S. 2nd ST. NATIONAL TO ST. PAUL

Subject: Project ID #2245-01-00
South 2nd Street
Capacity/Quality of Service Analysis

TECHNICAL MEMORANDUM

EXISTING TYPICAL CROSS SECTIONS

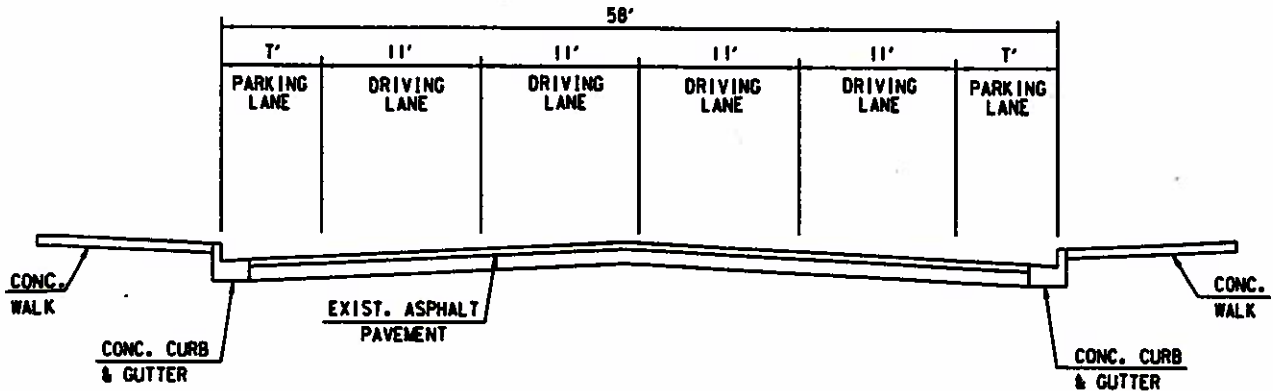
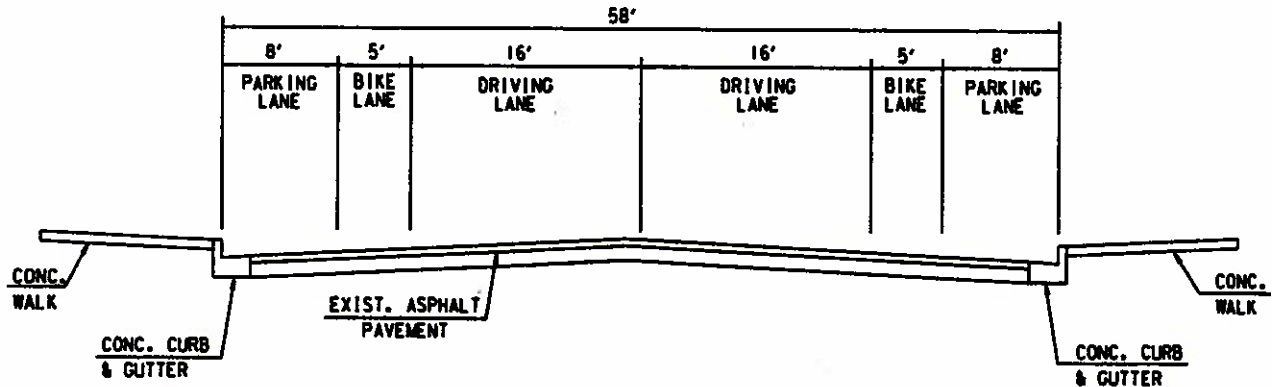
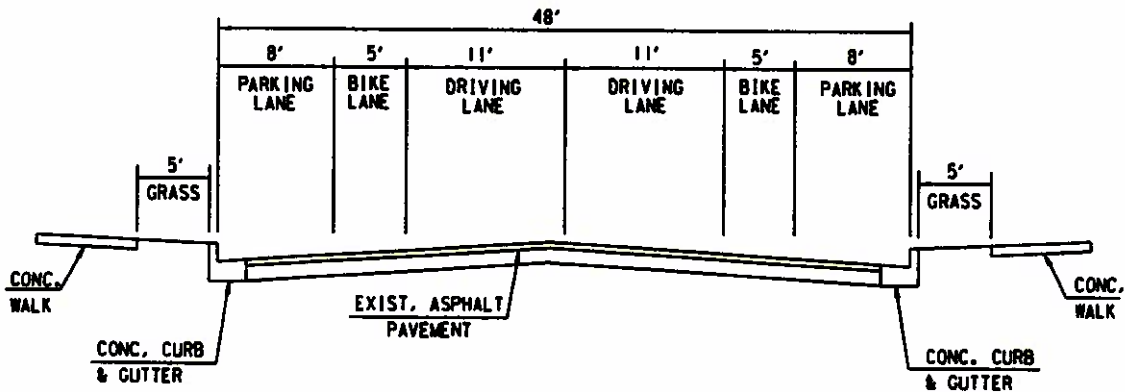
The results of the analysis indicate that the performance measures for pedestrians, transit, and bicycles will improve slightly, within the same LOS. However, the removal of a lane on South 2nd Street will result in the LOS degrading from LOS A under the existing configuration to LOS B with 16' lanes and LOS C with 11' lanes. In addition, the volume to capacity ratio of the southbound approach at West National Avenue will degrade from 0.62 to 0.82 with 16' lanes and 0.96 with 11' lanes. These ratios indicate that under normal traffic variance within the peak period, the southbound approach at West National Avenue will become oversaturated, resulting in sporadic congestion.

We hope this information will define the anticipated conditions during the design year for each of the four travel modes under the three design alternatives being considered. While this analysis indicates the **best operating conditions can be achieved overall under the current geometric configuration**, please advise if federal cost participation will be available for any of the single lane alternatives being considered.
